**CITY OF DANIA BEACH CITY COMMISSION MEETING
SEPTEMBER 14, 2020 at 7:00 PM
VIRTUAL MEETING AND PUBLIC COMMENTS PROCEDURE**

A RESOLUTION OF THE CITY COMMISSION OF THE CITY OF DANIA BEACH, FLORIDA, APPROVING THE SITE PLAN FOR THE CONSTRUCTION OF A 144,541 SQUARE FOOT INDUSTRIAL WAREHOUSE BUILDING IN THE I-G (INDUSTRIAL) ZONING DISTRICT (SP-039-20), SUBMITTED BY U.S. CRANE AND RIGGING, LLC, ON BEHALF OF THE PROPERTY OWNER PAMELA KAY HAYES, AS TRUSTEE OF THE ROBERT L. ELMORE JULY 2010 RECOVERABLE TRUST, FOR PROPERTY LOCATED AT 2980 W STATE ROAD 84, IN THE CITY OF DANIA BEACH, FLORIDA; PROVIDING FOR CONFLICTS; FURTHER, PROVIDING FOR AN EFFECTIVE DATE. *(Community Development)*

A RESOLUTION OF THE CITY COMMISSION OF THE CITY OF DANIA BEACH, FLORIDA, APPROVING THE SITE PLAN AND SPECIAL EXCEPTION (SP-042-20/SE-048-20) FOR THE CONSTRUCTION OF A 14,000 SQUARE FOOT SPECIALTY SCHOOL AND VARIANCES (VA-043-20/VA-044-20/VA-045-20/VA-046-20/VA-047-20/VA-063-20) FOR PARKING SPACES, BUILDING PLACEMENT, LANDSCAPING, DUMPSTER LOCATION, PERIMETER WALL, AND HEIGHT, SUBMITTED BY SALTZ MICHELSON ARCHITECTS ON BEHALF OF AMOPT, LLC, FOR THE PROPERTY LOCATED AT 922 S. FEDERAL HIGHWAY, IN THE CITY OF DANIA

Sheet 3 of 3

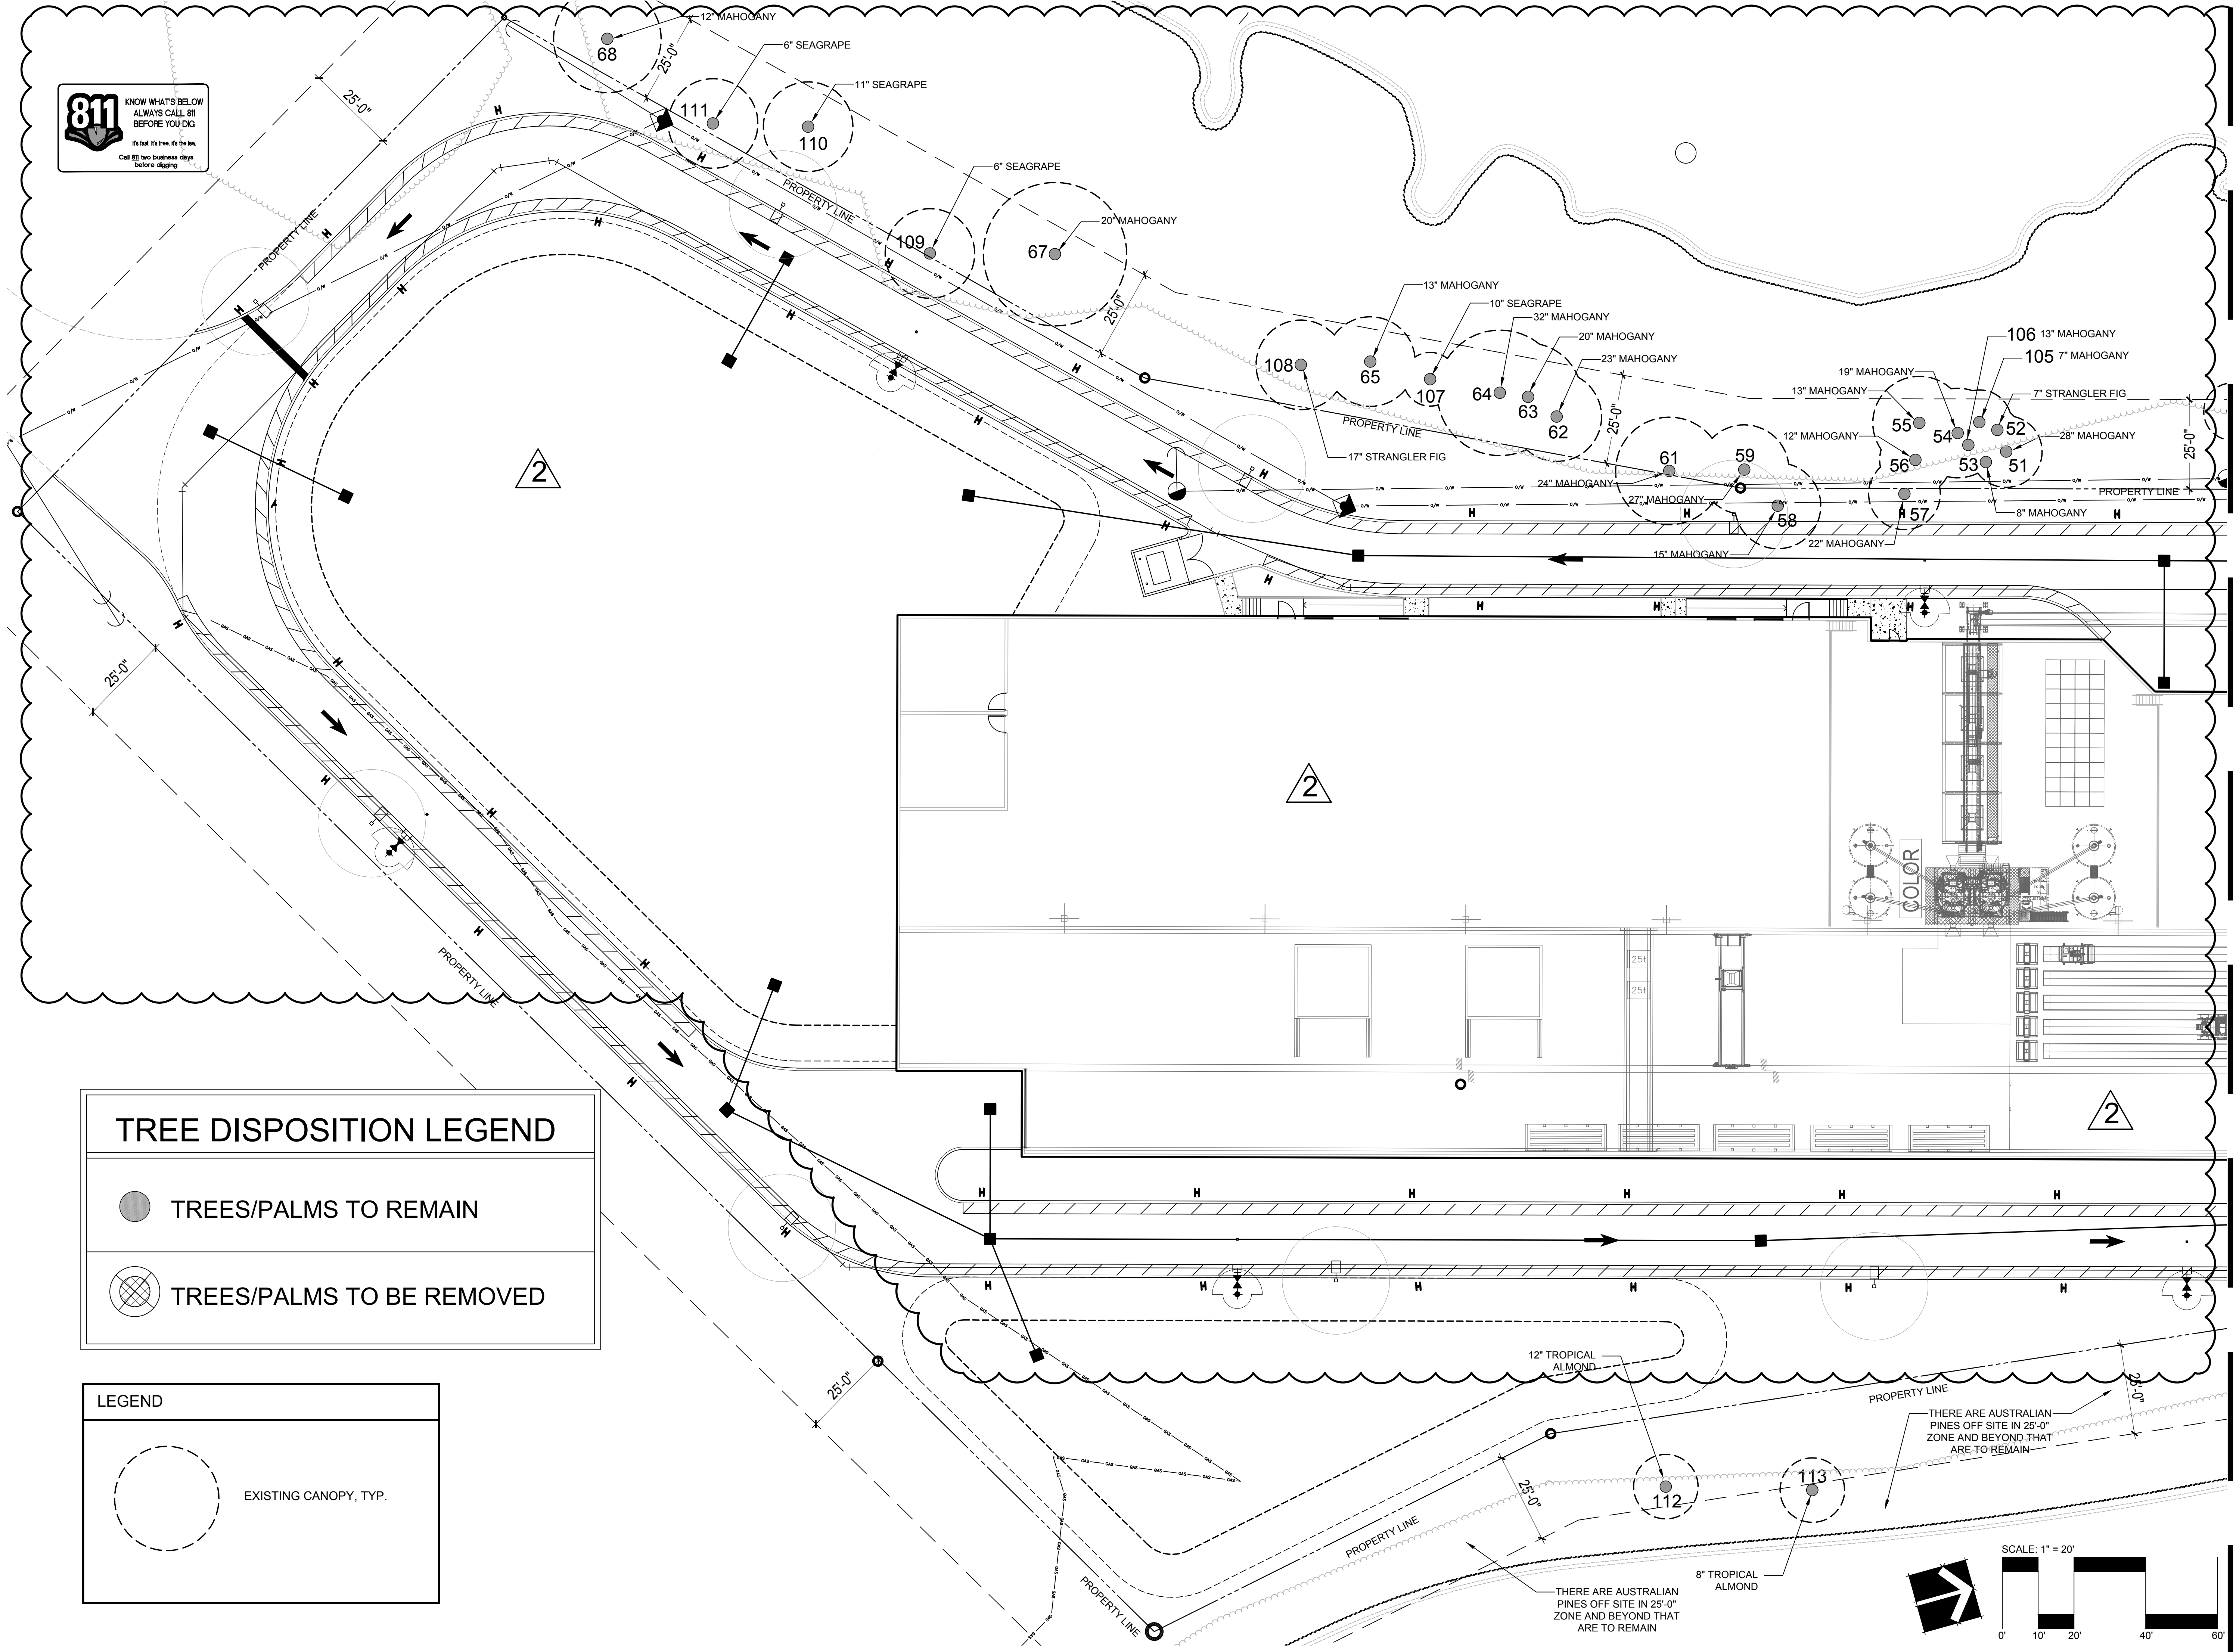
7. Provide the percentage of non-VUA open space to verify the non-VUA requirements in the Requirements table on sheet LP-3.
8. Provide a code compliance landscape sheet that gives each tree a specific symbol in order to verify which code requirement each tree is counted towards.

9. Include the Sec. 275-90(C) VUA perimeter buffer and buffer width requirements in the Requirements table on sheet LP-3.
10. Provide the requirements of Sec. 275-90(E)(1), VUA landscape areas abutting buildings in the Landscape Requirements table on sheet LP-3.

RESPONSE: the non-VUA open space is provided on sheet LP-3 it is 115,098 S.F. or 36.8%.

PLANTING PLAN NOTES:

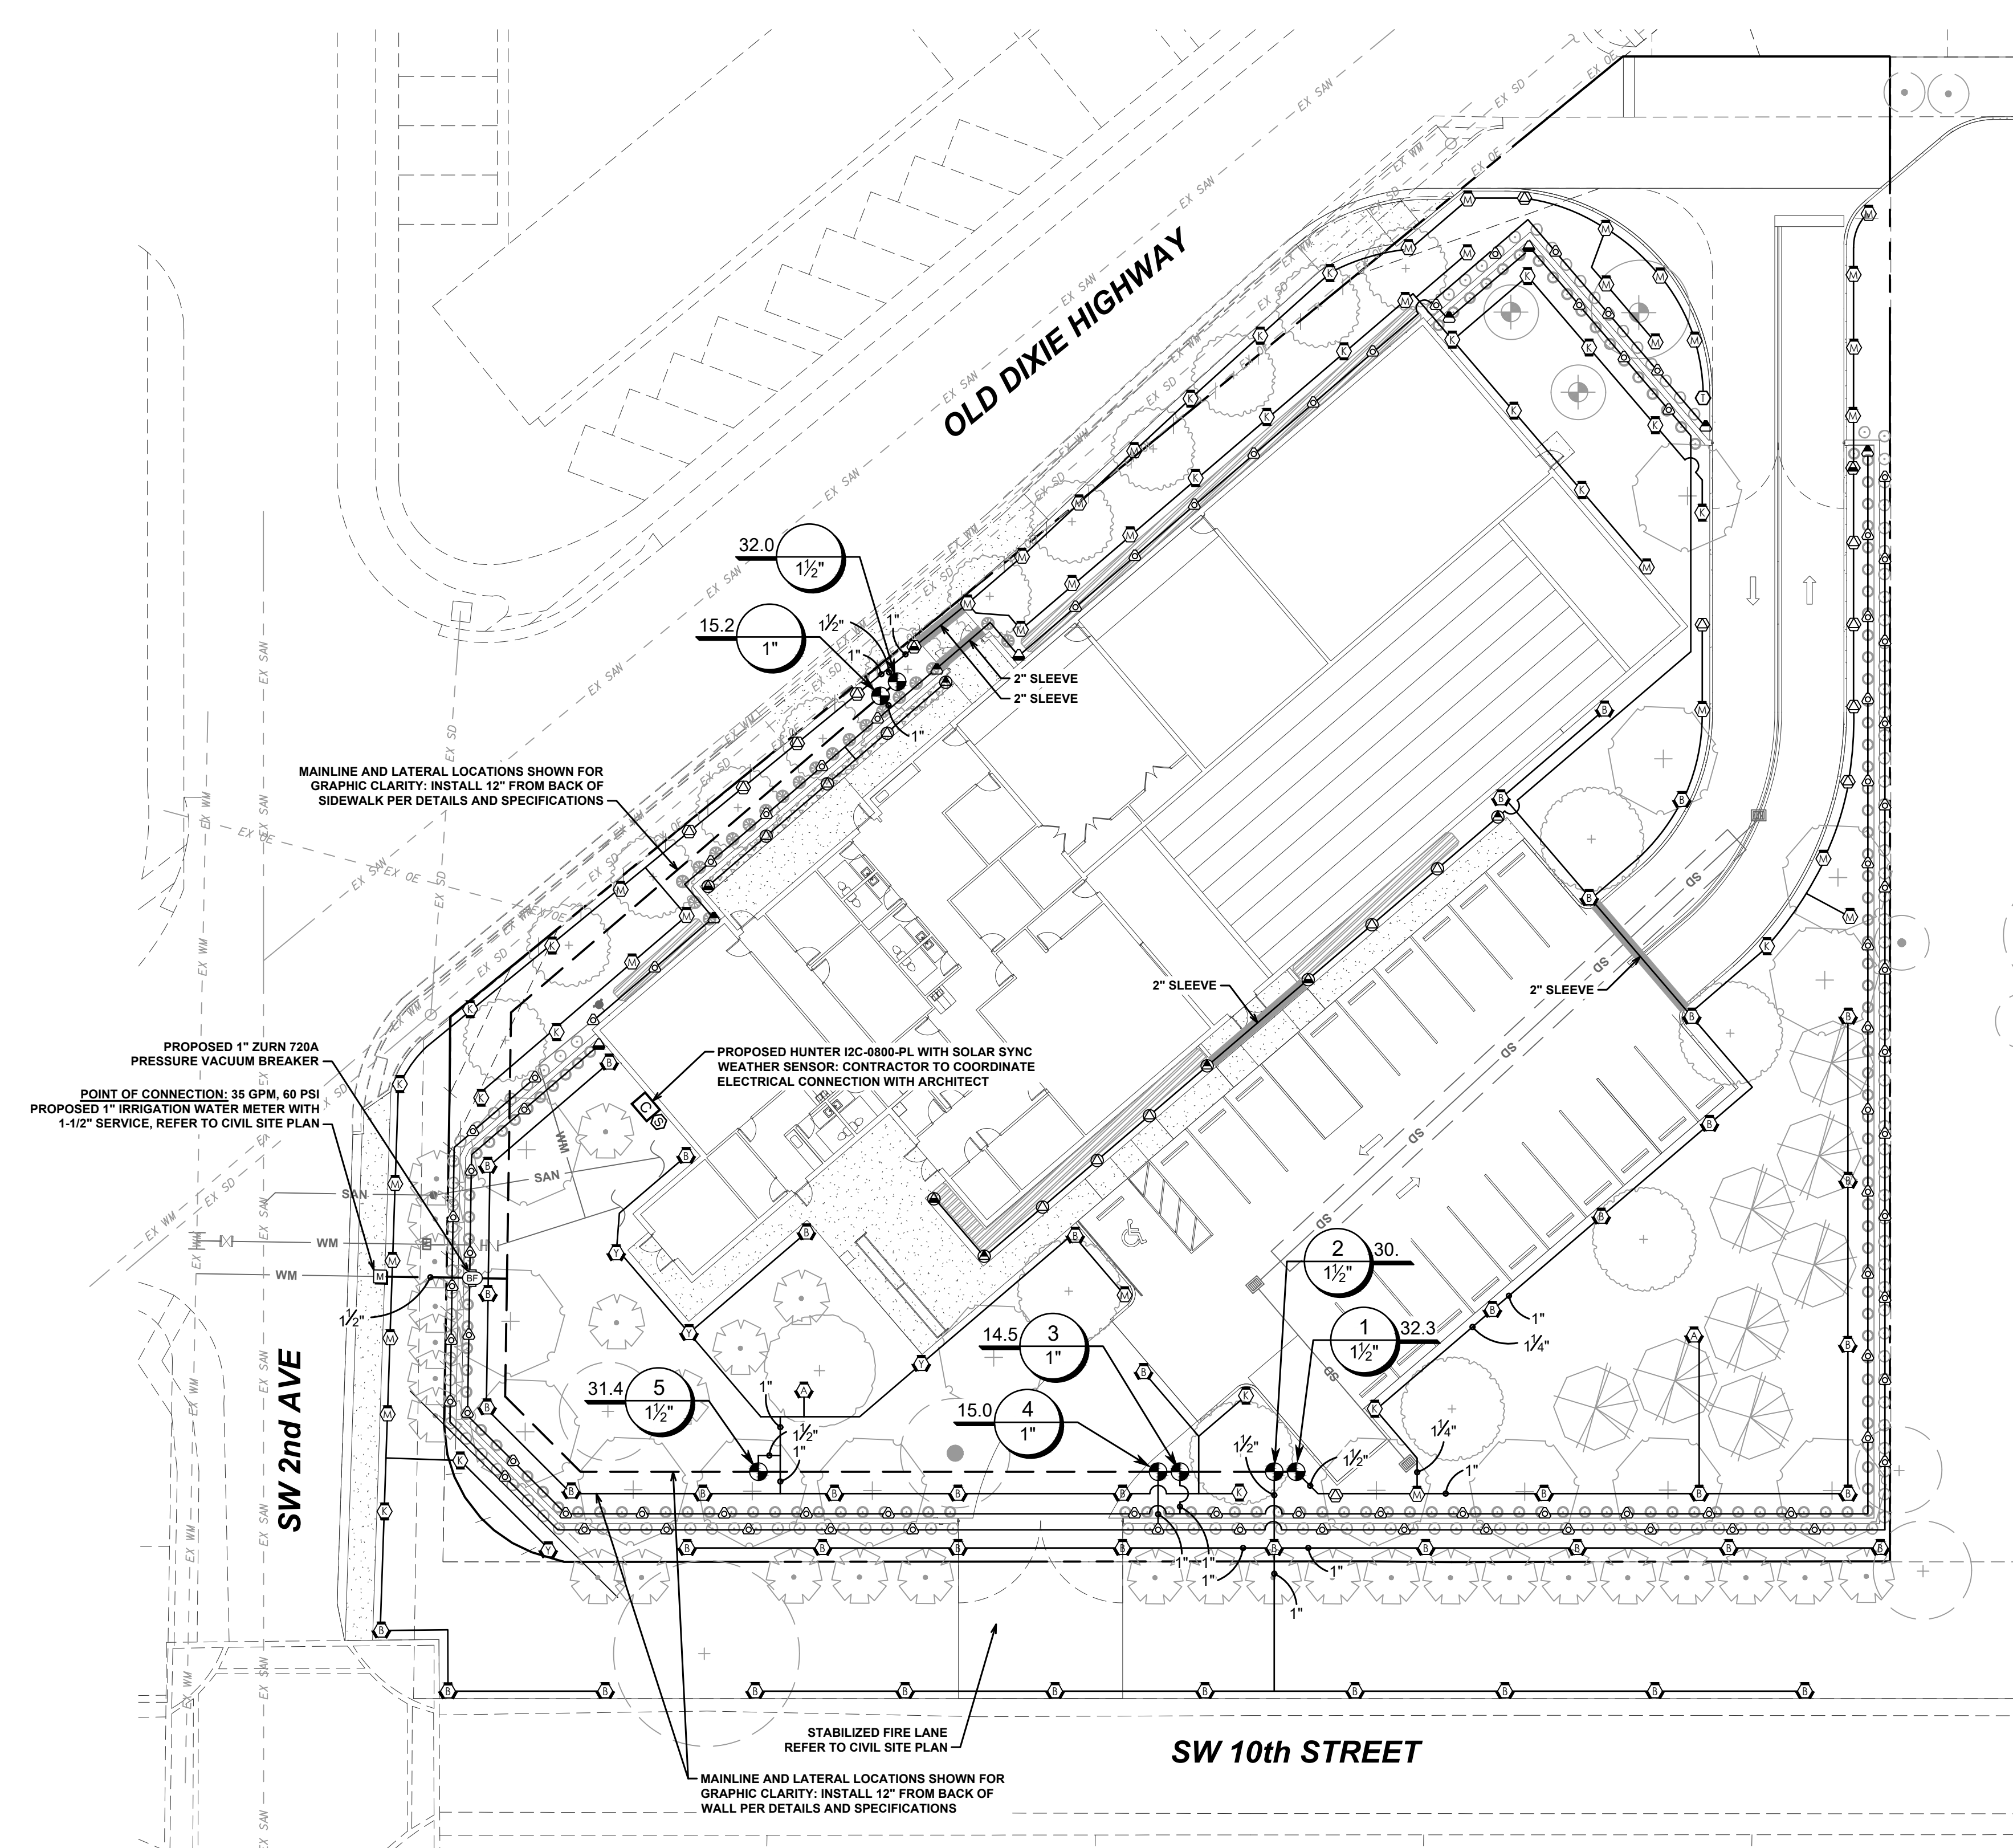
1. Per Sec. 275-190(O), provide a note on the plan (sheet L-2) that says root barrier will be installed for any tree or palm planted within 10 feet of any sidewalk or parking area.

Response: This note was added to the plan, Sheet L-1.
